Attachment 1
Findings
PA20-0132

D'ESPOSITO RESIDENCE
1507 Emerald Bay, Laguna Beach, CA 92651

PRELIMINARY APPROVED 08-20-2020

ROOF PLAN

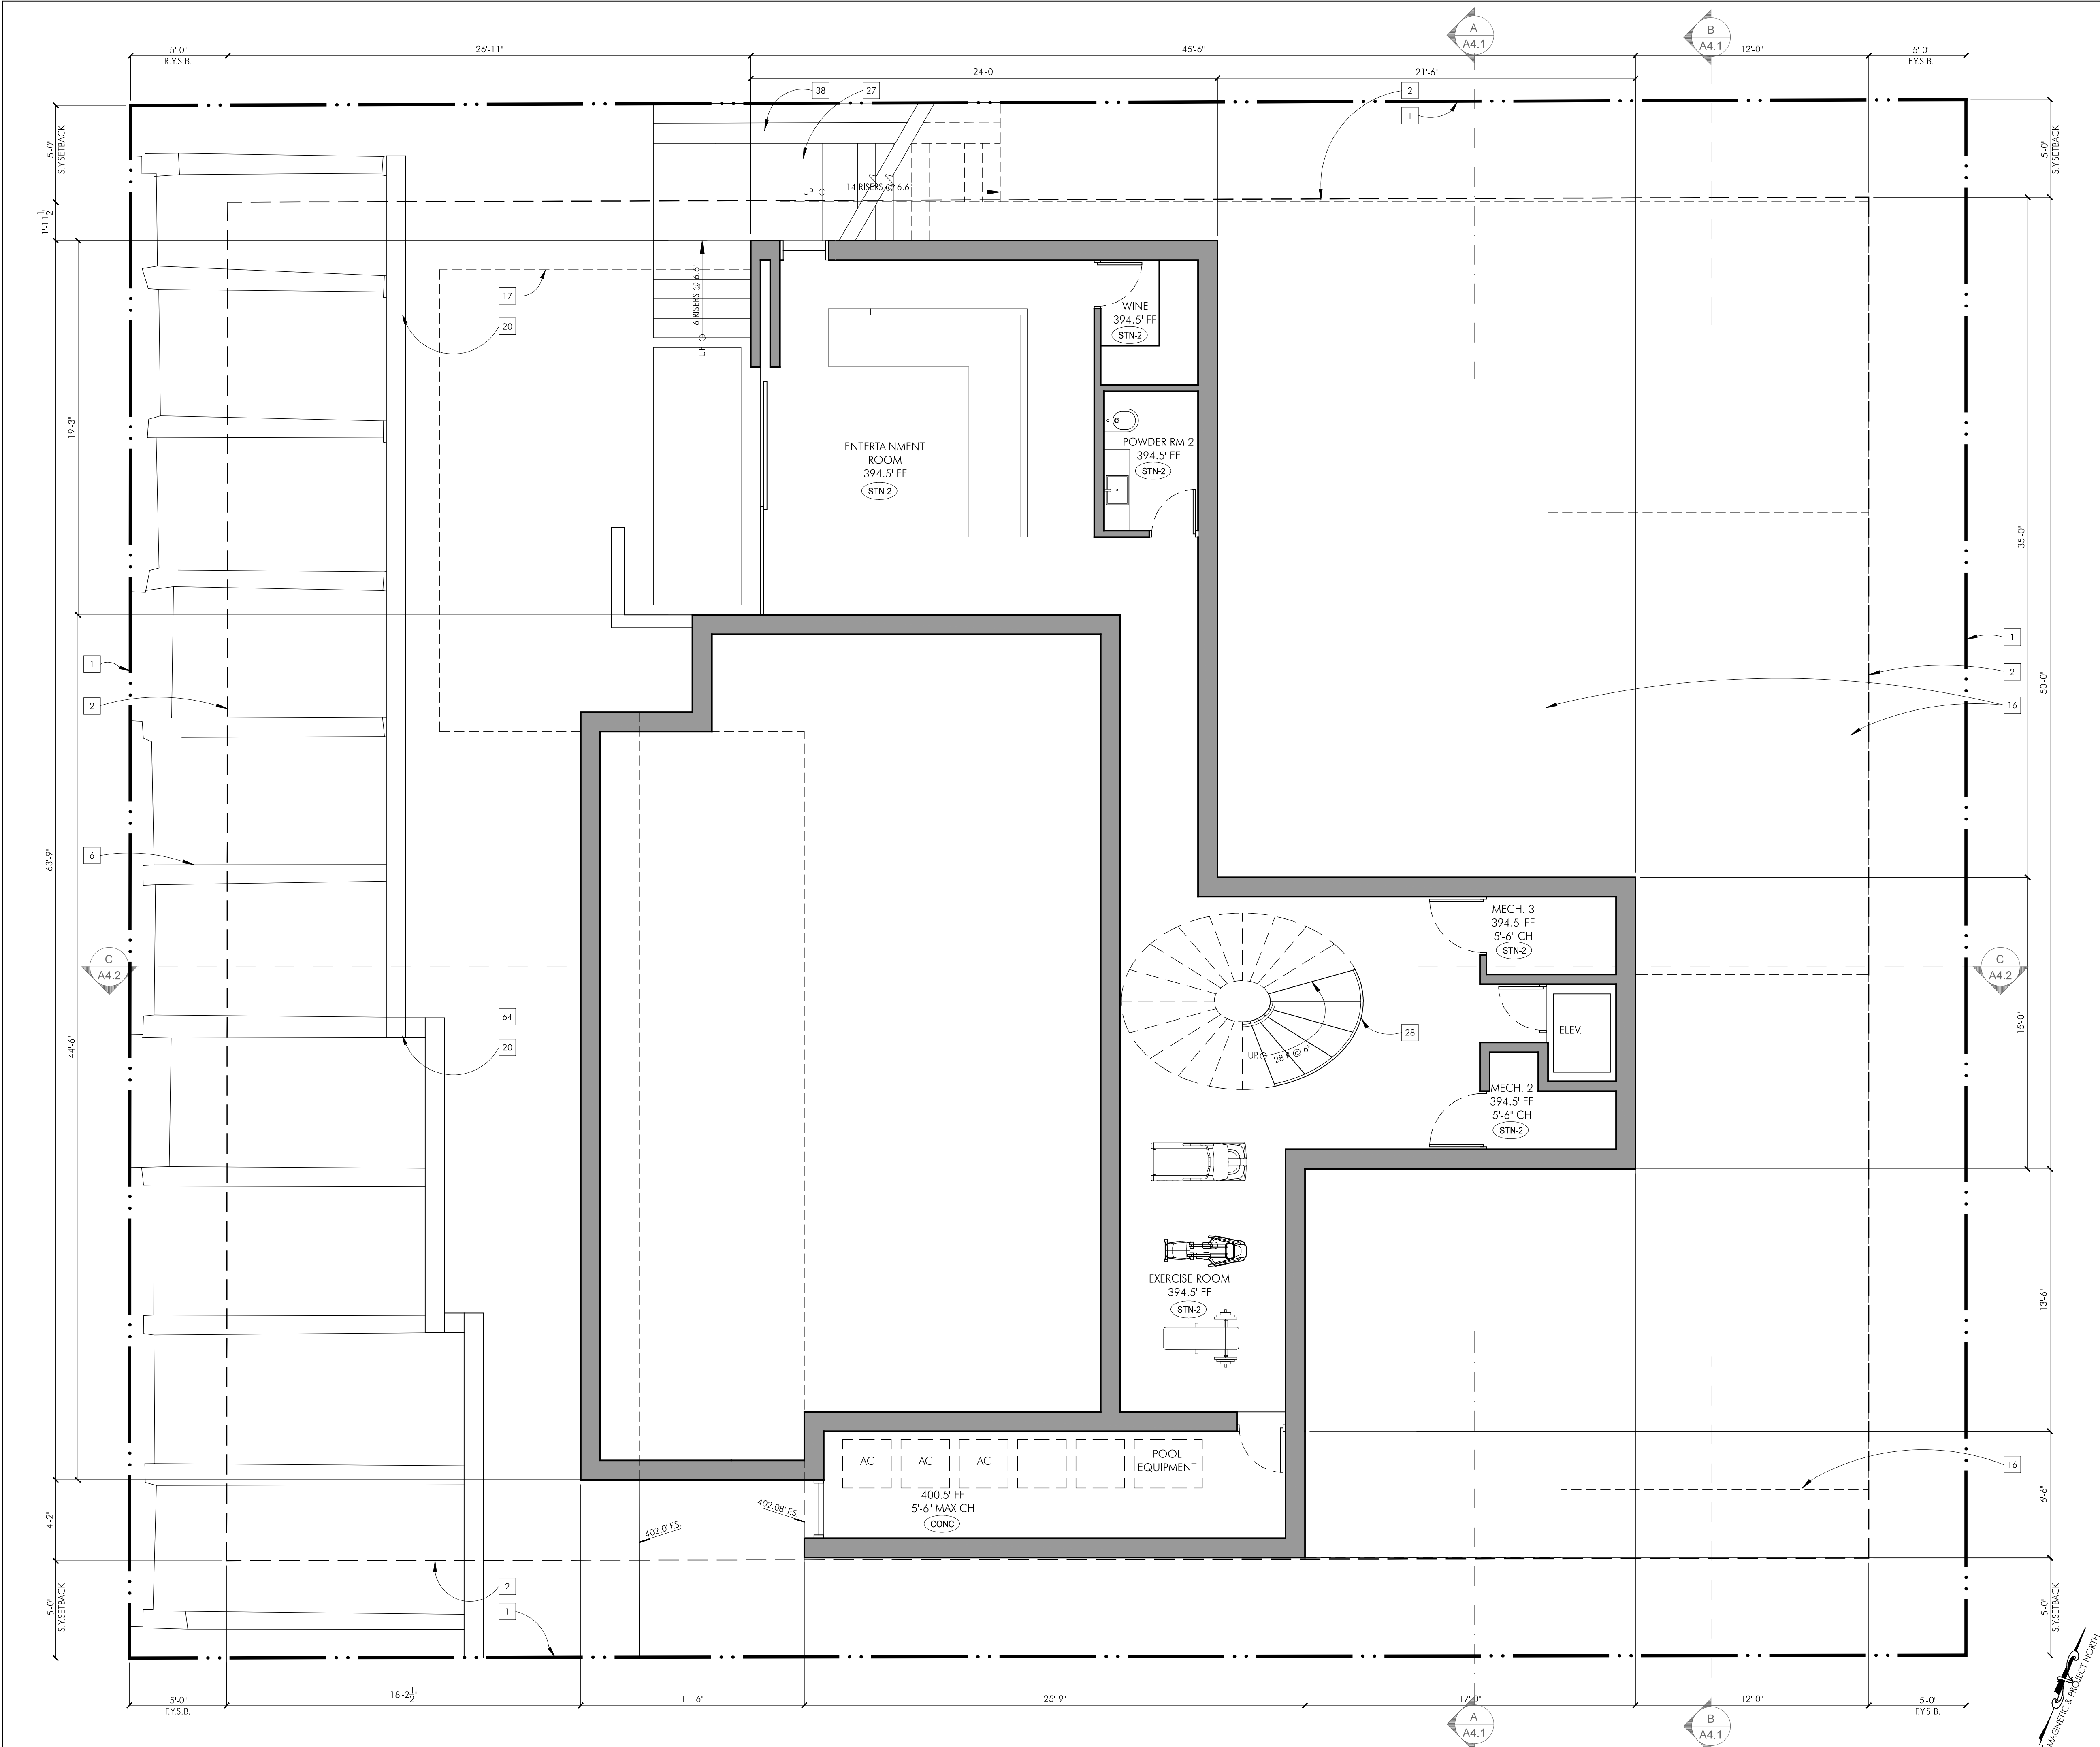
21. **GUTTERS AND DOWNSPOUTS (Section D.13):** Shown on roof plan and detail 2/AD1 as recessed internal gutters. **Identify locations for downspouts. Identify method of drainage at raised Decks.**

- h. Identify locations for downspouts and method of drainage at raised Decks. **Deck drains with internal downspouts OK**
- i. Coordinate the Civil, Architectural and Landscape plans at the Service Yard. **Updated OK**

SHEET NUMBER
A4.2

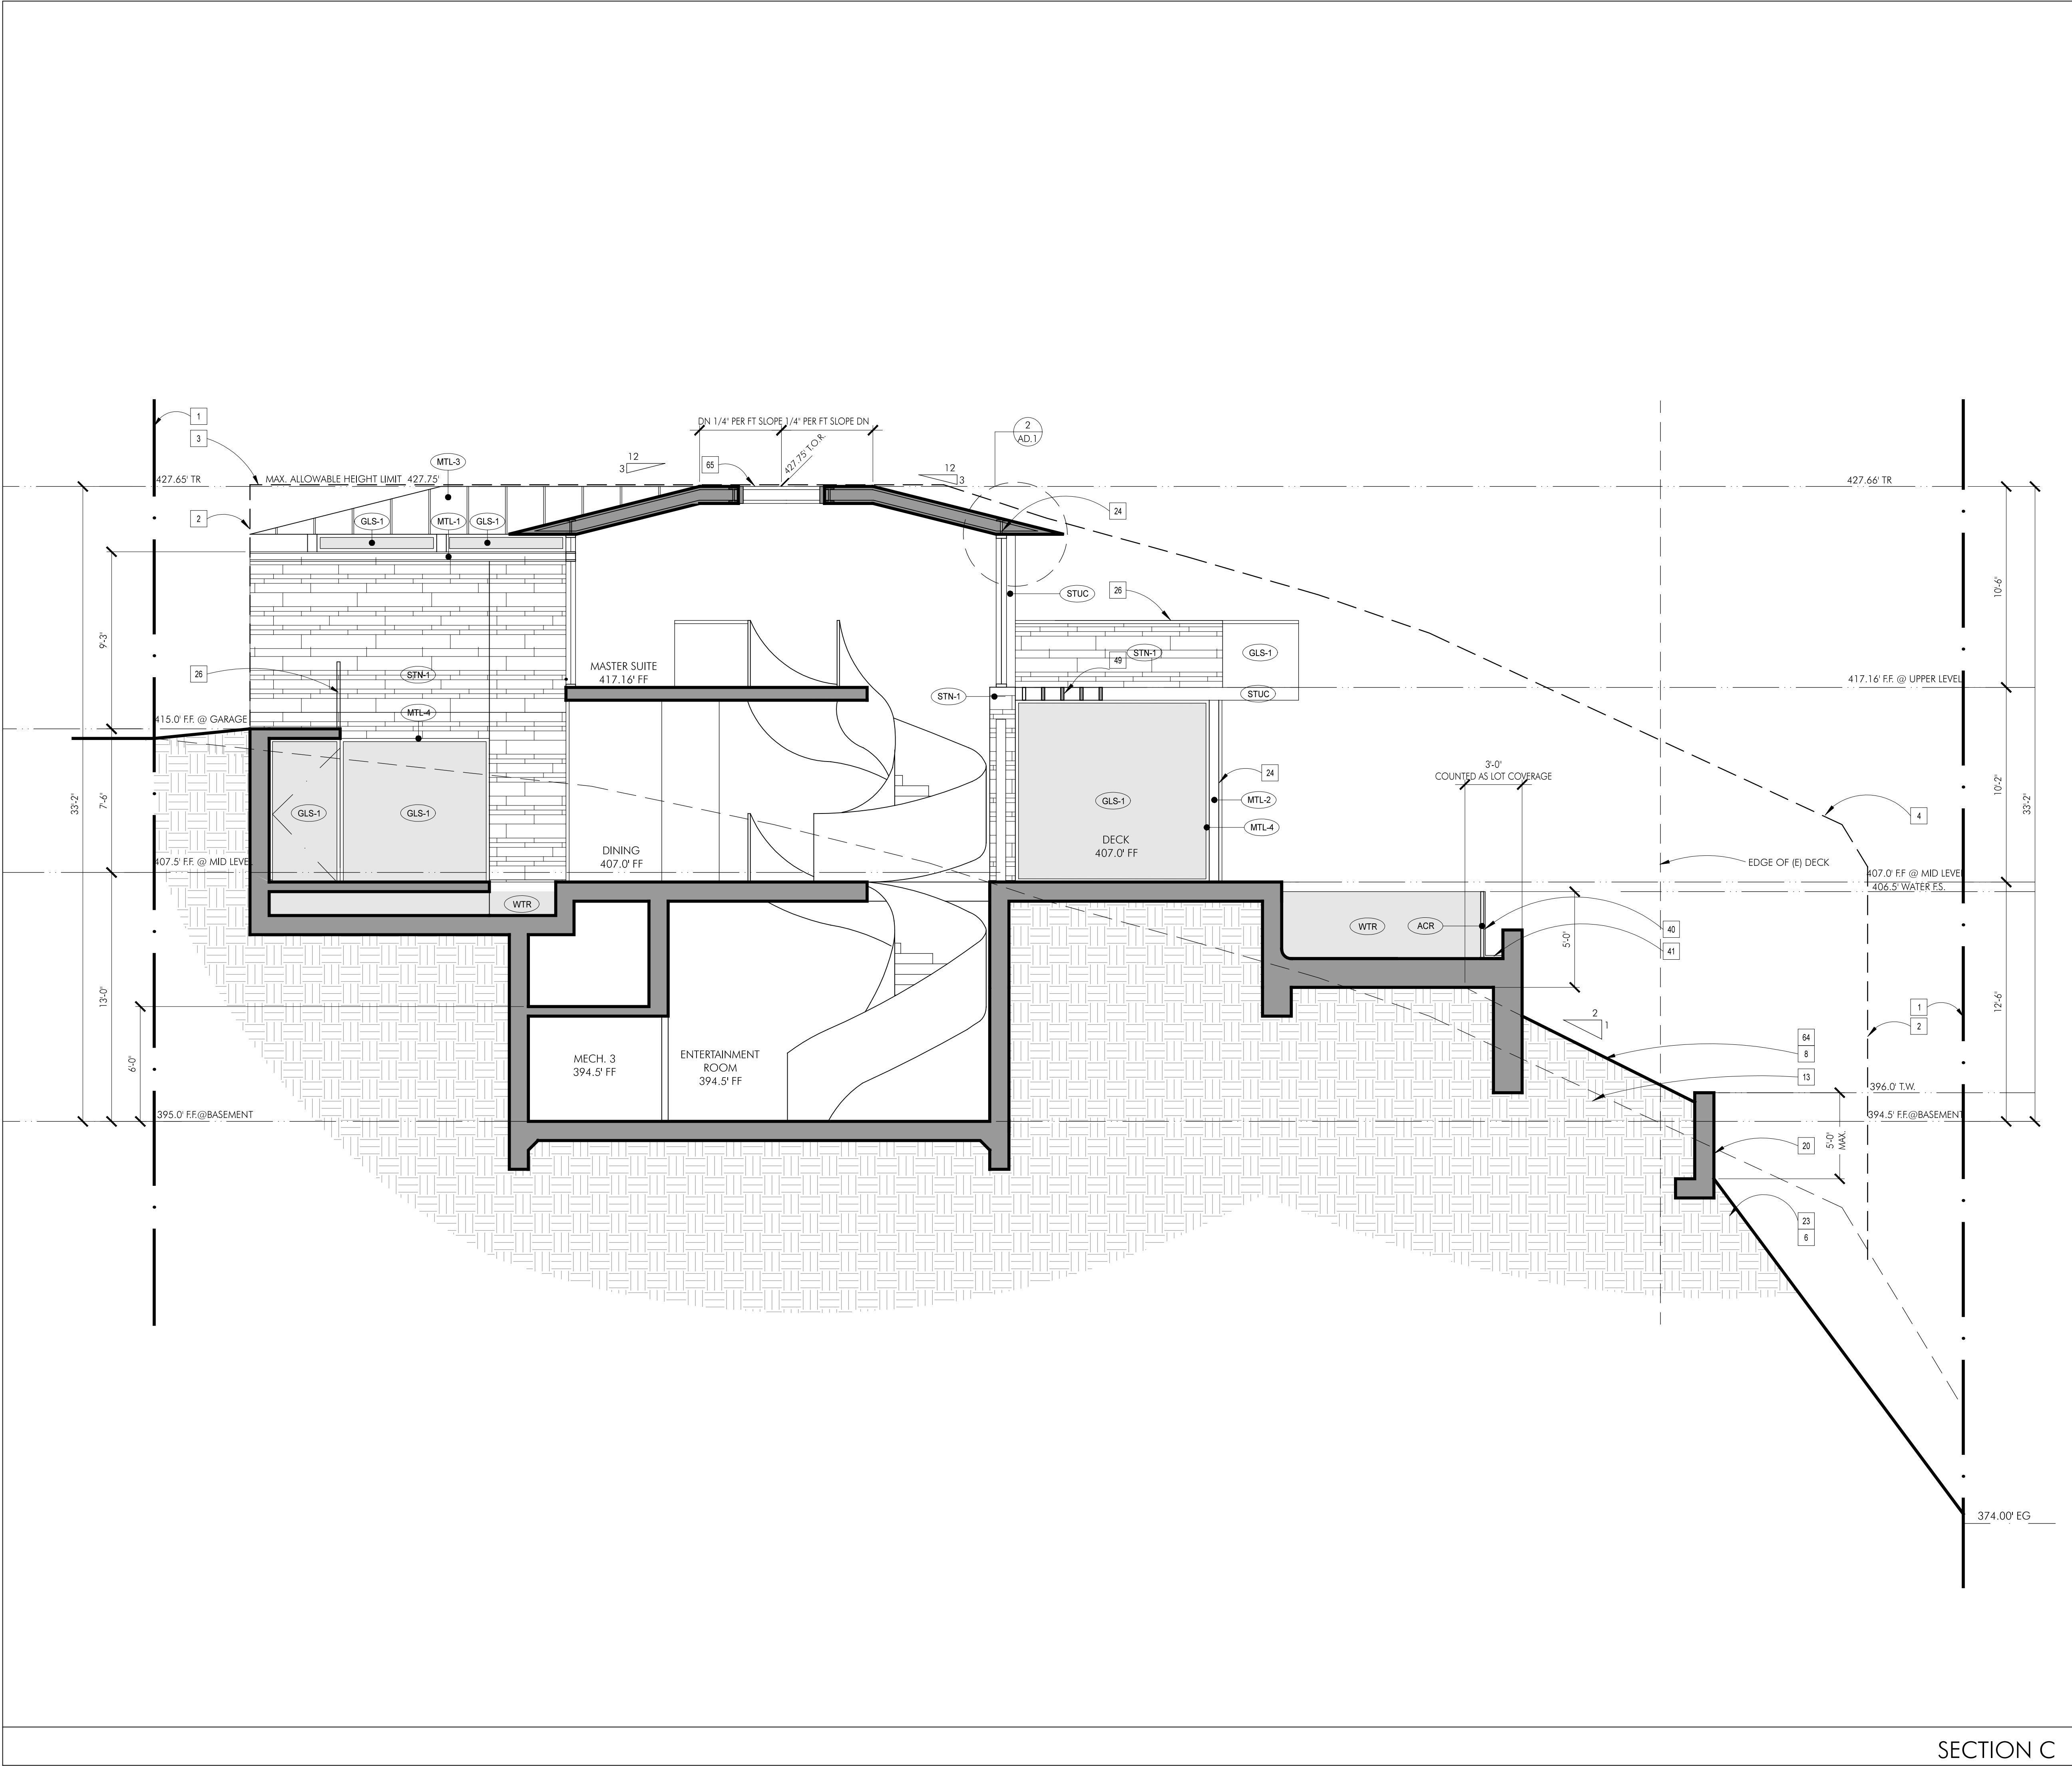
It has been noted that the center roof skylight and adjacent flat roof is pushing the 15' height maximum. Information on the flush skylight was provided but noted that the skylight will be sloped at 1/4" / FT. The section on sheet A.4.2 shows a center break on the skylight requiring it to slope in two directions. This is unclear with the information provided.

- f. Identify skylights as non-reflective. **Note added OK**
- g. Clarify the center break shown on the skylight or otherwise correct the pitch to show that it can stay within the height envelope. **Clarified OK**
